LiDAR Quality Assurance (QA) Report  
Louisiana LiDAR ARRA Project - Region 2  
October 11, 2011

Submitted to:  
USGS

Prepared by:  
 **Dewberry**

<p><b><u>Contract:</u></b> Louisiana ARRA Region 2</p>	<p><b><u>Production Contractor:</u></b> Woolpert Inc.</p>	<p><b><u>Date Prepared:</u></b> 10/11/2011</p>	<p><b><u>Delivery #:</u></b> 3</p>	<p><b><u>Dewberry Recommendation:</u></b> Accept</p>
<p><b><u>Data History:</u></b></p> <ul style="list-style-type: none"> <li>• 1st delivery June, 2011.</li> <li>• 2nd delivery arrived September, 2011.</li> <li>• 3<sup>rd</sup> delivery arrived October, 2011.</li> </ul>

Figure 35 – Error Remains. Full point cloud for tile RBT790370, second delivery. A very bright return from in the LiDAR intensity has been incorrectly captured as an island. The island breakline indicated by the arrow should be removed and the area should be captured as water.

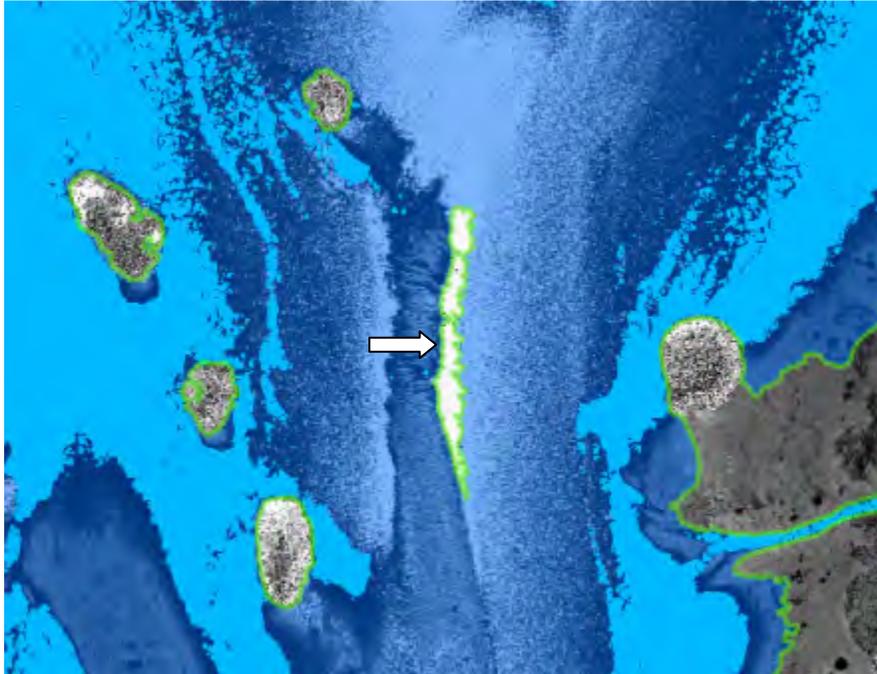
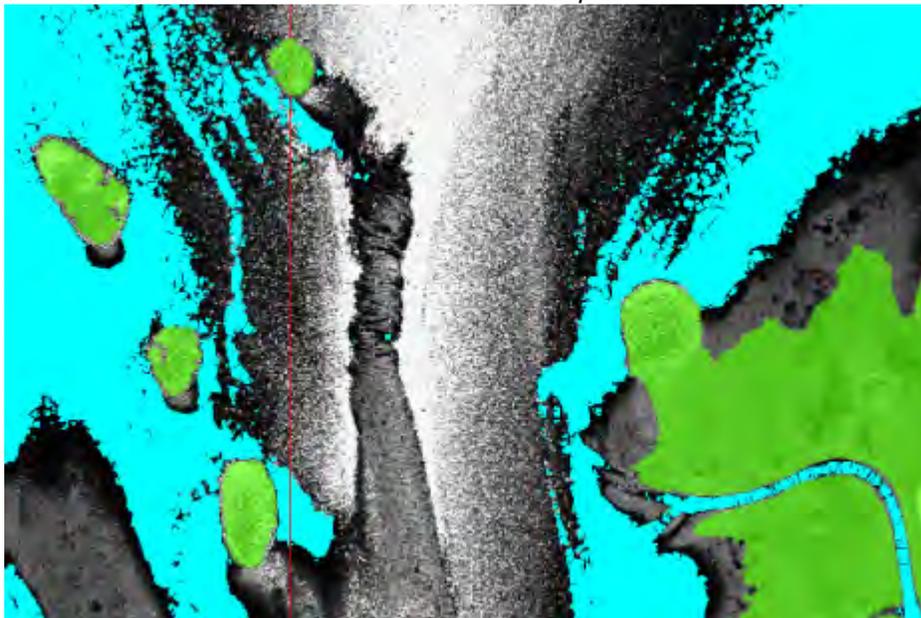
delivery. Five issues remain in the data set, including areas where a very bright intensity return off water has been incorrectly captured as ground (Figure 35).

Figure 36 – Full point cloud for tile RBT790370, third delivery. The island breakline has been correctly removed and the area is now captured as water.

*Figure 39 – Issue remains but no fix required. Ground elevation model of tile rbu100090 showing a floating water feature.*

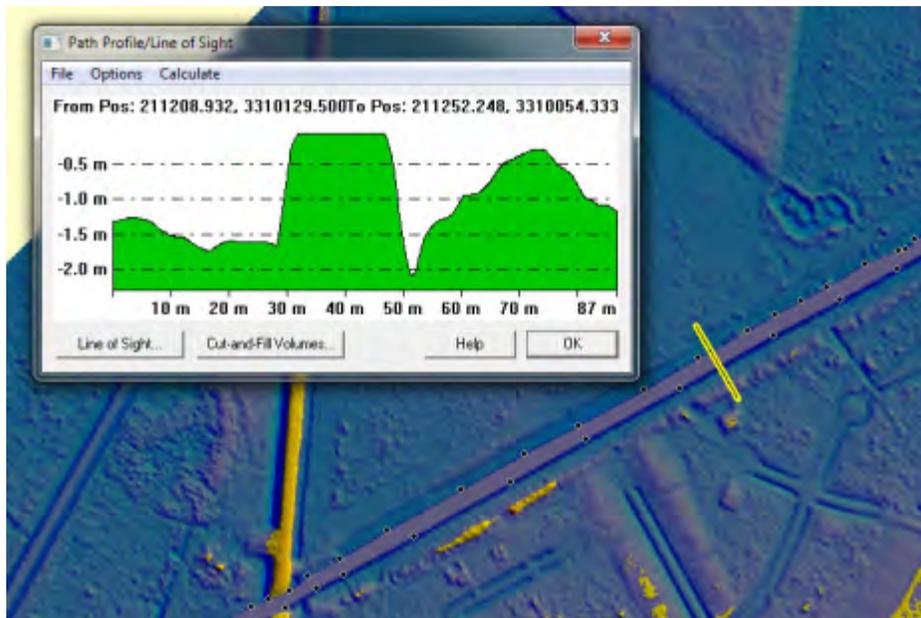
Several vertices were discovered that float above the terrain surface. In the first delivery Dewberry reviewed and identified 30 water features that significantly float above the water. Of these 30 floating water bodies Dewberry identified 10 that were not corrected in the second delivery of the breaklines. Additionally, four new areas of floating water were detected. These issues may be caused by the predetermined “0” elevation for water body features. The land around these breaklines is lower than 0 meters causing raised water bodies in the area. Examples can be seen in Figure 39 to Figure 41. A point feature class will be provided that details where the vertices are that float. The previous digging water body was corrected in the second delivery (Figure 42 and Figure 43).

Woolpert responded to these floating water bodies in the 2<sup>nd</sup> delivery by writing, “Linework was automatically generated at the previously chosen “0” elevation. The data in this area was below 0, so it appears to float.” Dewberry discussed this issue with the USGS and because of the method used to collect breaklines it was determined that these floating areas would be acceptable in this delivery. The images below are provided to make the end-user aware of the issue.

Figure 44 – 1<sup>st</sup> delivery. Example of missing DEM tile (white arrow). Dewberry received LAS data for this area.

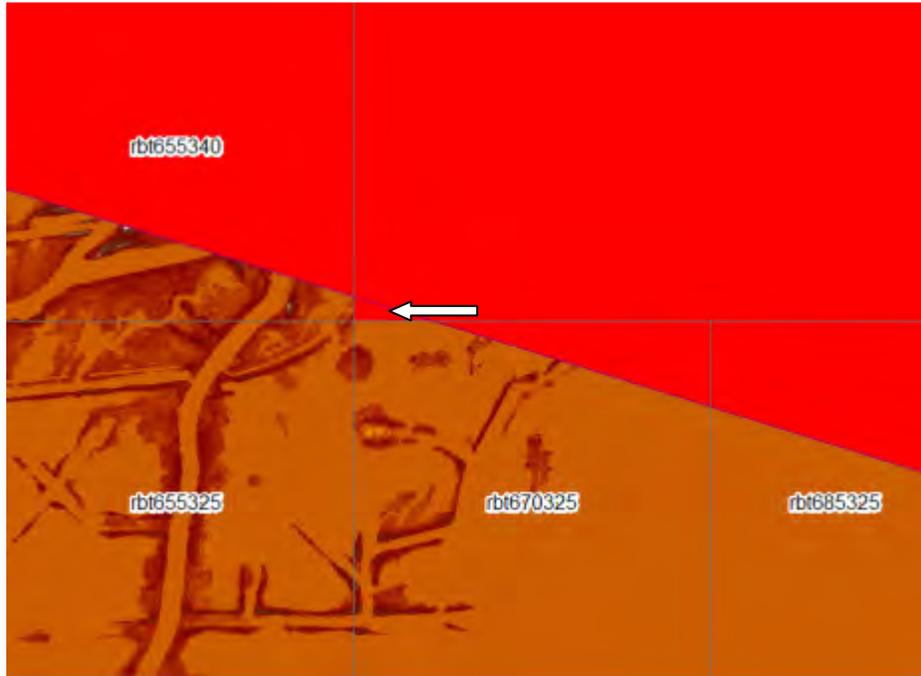
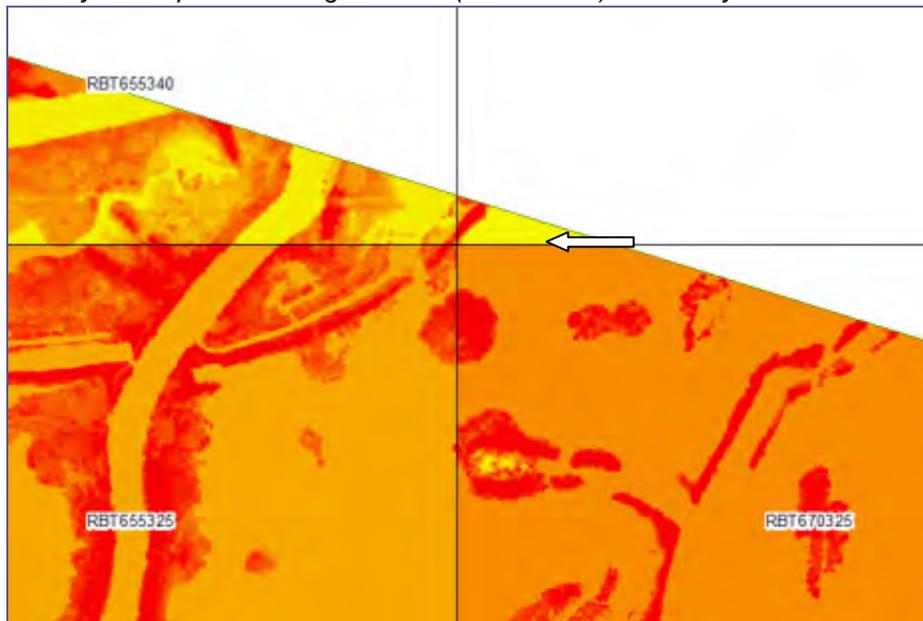
The first delivery of DEMs was missing 27 tiles that had LAS data (in addition to the 74 tiles Dewberry recommended be delivered to ensure no ground was overlooked). All missing DEMs were delivered in the second delivery. There are now 1290 DEMs which is consistent with the number of LAS tiles for the project.

Figure 45- 2<sup>nd</sup> delivery - Corrected. The missing DEM was included in the second delivery.

*Figure 46 – 1<sup>st</sup> delivery. Ground elevation model of several first delivery tiles. Tile rbt400685 has several null pixel values in the upper-right corner (In red).*

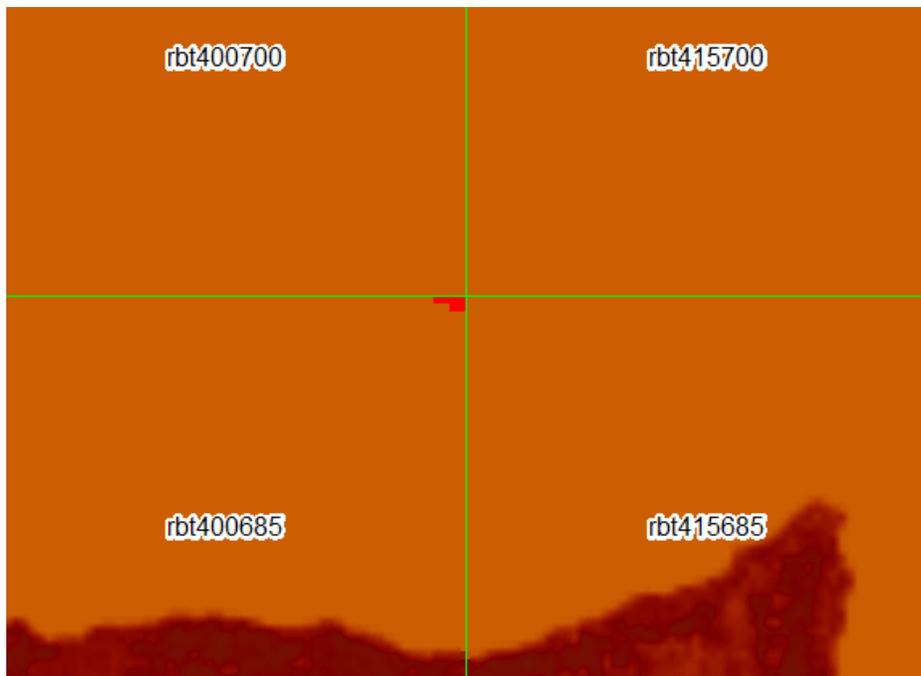
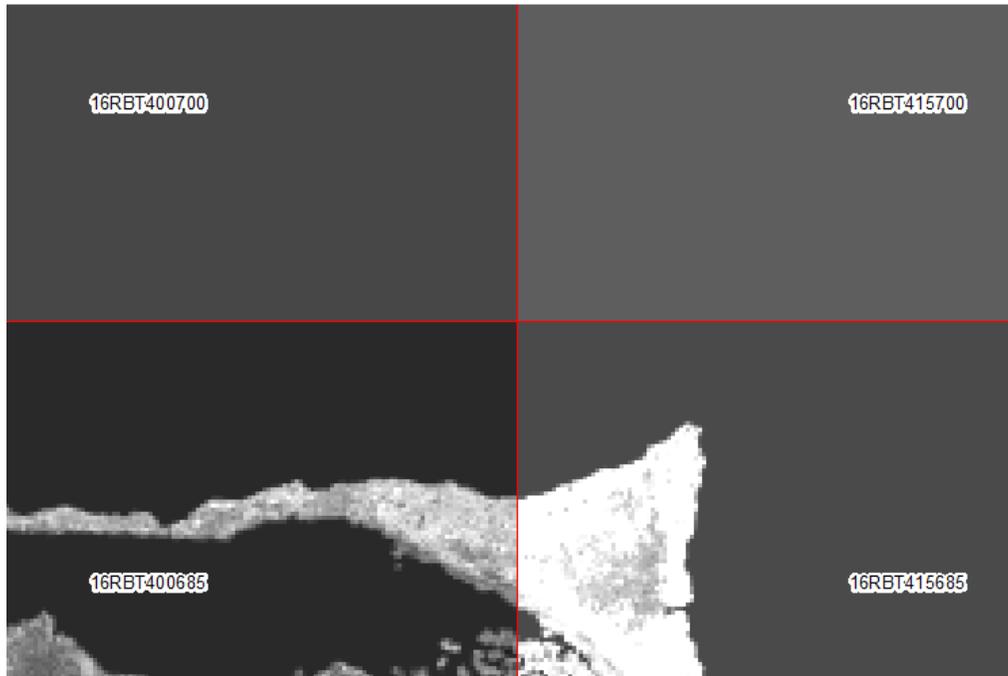
Dewberry also identified 11 tiles that have null pixels in the DEM that are not outside of the project boundary. Woolpert corrected all of these issues identified in the first delivery; however, Dewberry discovered 3 new DEMs with null pixels in the second delivery. Dewberry recommends these DEMs be reprocessed. Examples of the fixes and the new issues can be found below.

Figure 47 – 2<sup>nd</sup> delivery - Corrected. Ground elevation model of the second delivery of tile rbt400685. The null pixel values have been corrected.

Figure 50 – 1<sup>st</sup> delivery. Ground elevation model of tile 16RBT940280, first delivery. The areas in between the islands are delineated in the breaklines as water, but this is not reflected in the DEM.

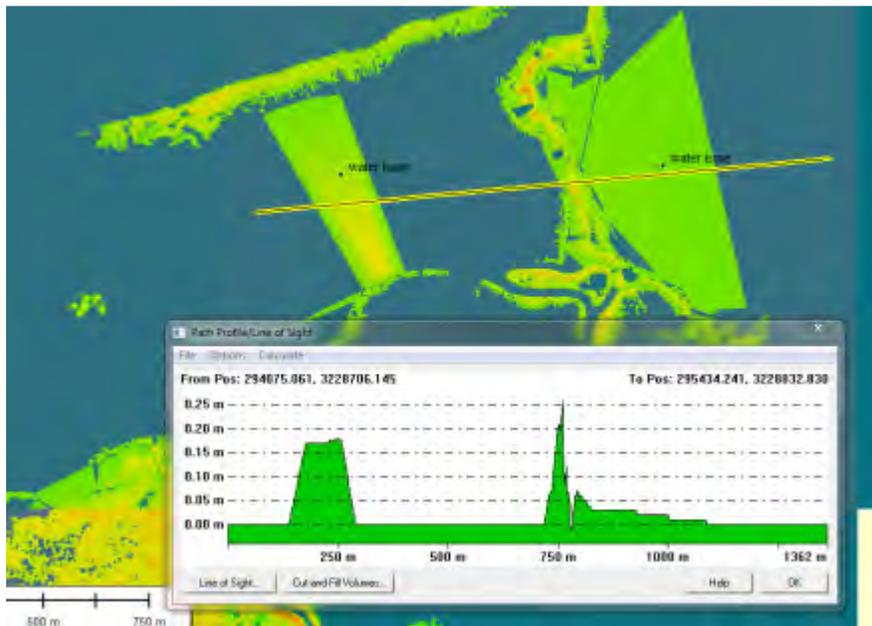
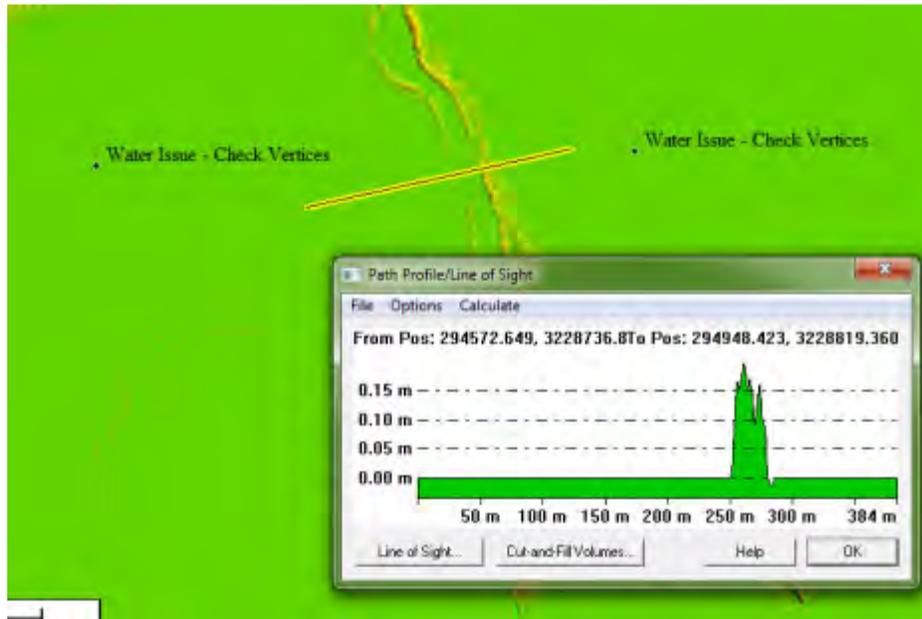
These issues are likely related to the breaklines and the classification to water step, but they are clearly identified in the DEMs and therefore mentioned here. In the first delivery, Dewberry identified several areas of artifacts appearing in water. Water artifacts called out by Dewberry in the first delivery were corrected; however, six new water artifacts were detected during the visual DEM QA of the second delivery. All six of these water artifacts were corrected in the third delivery. See figures below.

Figure 51- 2<sup>nd</sup> delivery – Corrected. Ground elevation model of tile 16RBT940280, second delivery. The water artifacts have been removed in the second delivery.
